Discussion of "Mechanics of Progressive Collapse: Learning from World Trade Center and Building Demolitions" by Zdeněk P. Bažant and Mathieu Verdure

March 2007, Vol. 133, No. 3, pp. 308–319.
DOI: 10.1061/(ASCE) 0733-9399 (2007)133:3(308)

Closure to "Mechanics of Progressive Collapse: Learning from World Trade Center and Building Demolitions" by Zdeněk P. Bažant and Mathieu Verdure

Zdeněk P. Bažant[1] and Jia-Liang Le[2]
[1]McCormick Institute Professor and W. P. Murphy Professor of Civil Engineering and Materials Science, Northwestern Univ., CEE, 2145 Sheridan Rd., Evanston, IL 60208. E-mail: z-bazant@northwestern.edu
[2]Graduate Research Assistant, Northwestern Univ.

Fig. 1. (a) Postulated plastic joint location; (b) deformed shape; (c) resistance deflection plot; and (d) and the thin wall section at the upper segment of building

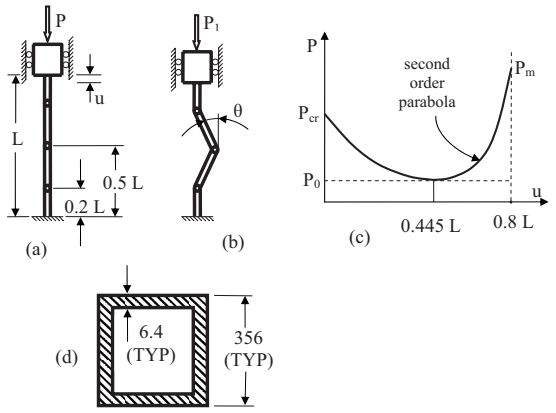
The first phase of column squashing in the plastic range is as shown in Fig. 1(c), with the rotation angle of $\theta = 75°$. The absorbed strain energy, up to that intermediate point, is

The final compacted length is taken as $0.2L$ and the $P-u$ curve (load-resistance) is assumed to be the second-order parabola, tangent to the horizontal at the intermediate point and reaching the value of $P_m = 2P_{cr}$. This peak load is to be applied for a very short time only, not sufficient to buckle the column. Besides, the floor mass is resisting some of the dynamically applied load.

1. **Load-Displacement Curve of Columns and Energy Absorption Capacity:** The discusser's curve of axial load P versus axial displacement u of a column (sketched in his figure 1(c) and redrawn to scale as the upper curve in Fig. 2 right is not correct and grossly overestimates the energy dissipation in the column (note that what the discusser denotes as P is in the paper denoted as F). The correct curve (Fig. 2, left), based on the theory of plastic large-deflection buckling (Bažant and Cedolin 2003, Sec. 8.6), is given by Eq. 8 in Bažant and Zhou (2002) and reads

- The discusser's expression $P_0 = M_0/0.3L \sin\theta_2$ for the lowest point of his $P(u)$ curve is not correct. This expression was apparently derived from equilibrium of the column segment as a free body, as shown in Fig. 5(c) of Bažant and Zhou 2002, but only one of the two plastic moments M_0 acting at the segment ends (shown in that figure) was considered. Considering both plastic moments in that figure, one gets the correct expression $P_0 = 2M_0/0.3L \sin\theta_2$.

- The discusser assumes the upper and lower plastic hinges to be located at distances $0.2L$ from the column ends, rather than at the column ends. This assumption causes the rotation $\theta = 75°$ to be reached when the story height L is reduced only by $u = 0.445L$ [Fig. 1(c)] rather than by $0.8L$.

- For the curve $P(u)$ beyond the point $u = 0.445L$, the discusser assumes a rising parabola [see his Fig. 1(c) and Fig. 2 right, in this closure] instead of a continued softening response up to $u = 0.8L$ (Fig. 2 left). This assumed parabola greatly exaggerates the estimate of energy dissipation in the column. There is no reason for increasing resistance $P(u)$ until the debris is fully compacted. The debris behaves like gravel. From soil mechanics, it is known that when the density of a random system of particles such as sand, gravel, or debris is less than a certain critical density, the neighboring particles do not have a sufficient number of contacts to support load. Thus, thinking that flying and colliding debris in the tower can support any load is a mistake. Upon reaching the critical density (which the discusser assumes to occur at $u = 0.8L$), all the particles of debris suddenly lock in a sufficient number of contacts preventing their relative movements, and only then the compacted debris can support load. Hence, the $P(u)$ curve should

Fig. 1. Evolution of initial simultaneous crush up and crush down and its arrest within the first story being crushed

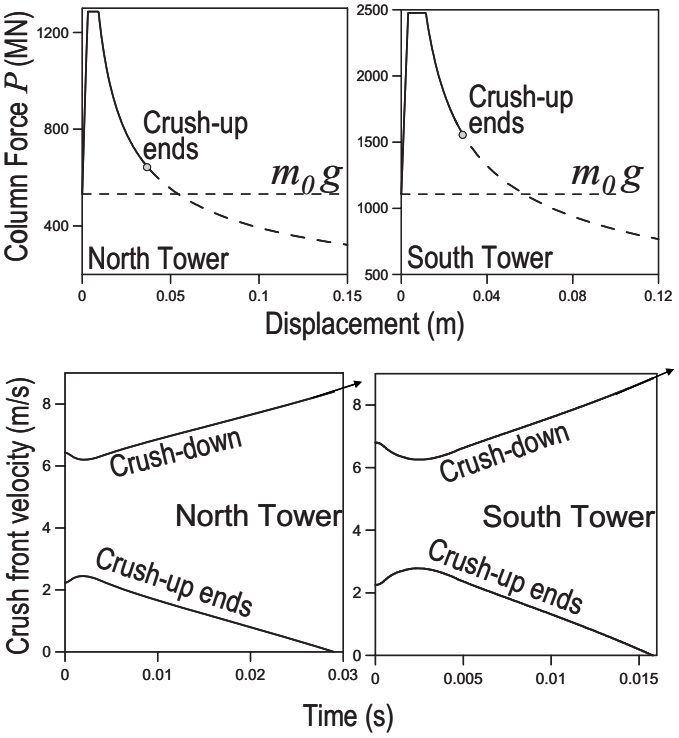
4. **Can Crush-Up Proceed Simultaneously with Crush Down?** It can, but only briefly at the beginning of collapse, as mentioned in the paper. Statements such as "the columns supporting the lower floors . . . were thicker, sturdier, and more massive," although true, do not support the conclusion that "the upper floors (i.e., the floors comprising Part C) would be more likely than the lower floors to deform and yield during collapse" (deform they could, of course, but only a little, i.e., elastically). More-detailed calculations than those included in their paper were made by Bažant and Verdure to address this question. On the basis of a simple estimate of energy corresponding to the area between the load-deflection curve of columns and the gravity force for crush down or crush up, it was concluded at the onset that the latter area is much larger, making crush-up impossible. We have now carried out accurate calculations, which rigorously justify this conclusion and may be summarized as follows.

Fig. 1 shows the calculated evolution of displacement and velocity during the collapse of the first overlying story in two-way crush. The result is that the crush-up stops (i.e., $|\dot{x}|$ drops to zero) when the first overlying story is squashed by the distance of only about 1.0% of its original height for the North Tower, and only by about 0.7% for the South Tower (these values are about 11 or 8 times greater than the elastic limit of column deformation). Why is the distance smaller for the South Tower even though the falling upper part is much more massive? That is because the initial crush-up velocity is similar for both towers, whereas the columns are much stronger (in proportion to the weight carried).

only an imperceptible difference in the results. The crush-up simultaneous with the crush down is found to have advanced into the overlying story by only 37 mm for the North Tower and 26 mm for the South Tower. This means that the initial crush-up phase terminates when the axial displacement of columns is only about 10 times larger than their maximum elastic deformation. Hence, simplifying the analysis by neglecting the initial two-way crushing phase was correct and accurate.

Fig. 3. Forces in dynamic equilibrium of upper Part C of tower at the beginning of crush down

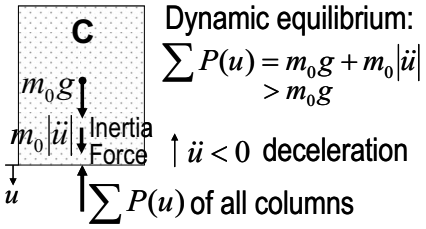
2. **Does Excess of P_{cr} over Gravity Load m_0g Imply Arrest of Collapse?** Not at all, and this point is generally misunderstood by critics. In the discussion section entitled "Initial Phase of Collapse—Heavily Damaged Story," the premise that "to cause initiation of failure, the buckling force P_{cr} had to be reduced to the level of applied load," would be correct in statics but not in dynamics, where the inertia forces must be taken into account, according to the d'Alembert principle.

The fact that P_{cr} exceeds the applied load (i.e., $P_{cr}>m_0g$) does not mean that the motion of the falling mass would get instantly arrested (which would require an infinite upward acceleration $|\ddot{u}|$ and thus an infinite resisting force). Rather, it simply means that the downward motion will continue as decelerated (Fig. 3) until the sum of the resisting forces $P(u)$ of all columns of the story (which begins with the plastic critical load P_{cr}) drops below m_0g. After that, the resistance $P(u)$ becomes less than m_0g, which means that the downward motion will be accelerated. This is clear from the calculated diagrams shown in the second and third rows of Fig. 4 in the paper.

Misled by the omission of inertia force (Fig. 3), the discusser reduces the critical load P_{cr} by the factor of 5.59 to make it equal to the gravity load (Fig. 2, right). This is impossible. The column strength is an objective property of the material and of the column geometry and not some fictitious property that can be adjusted according to the load to achieve static equilibrium.
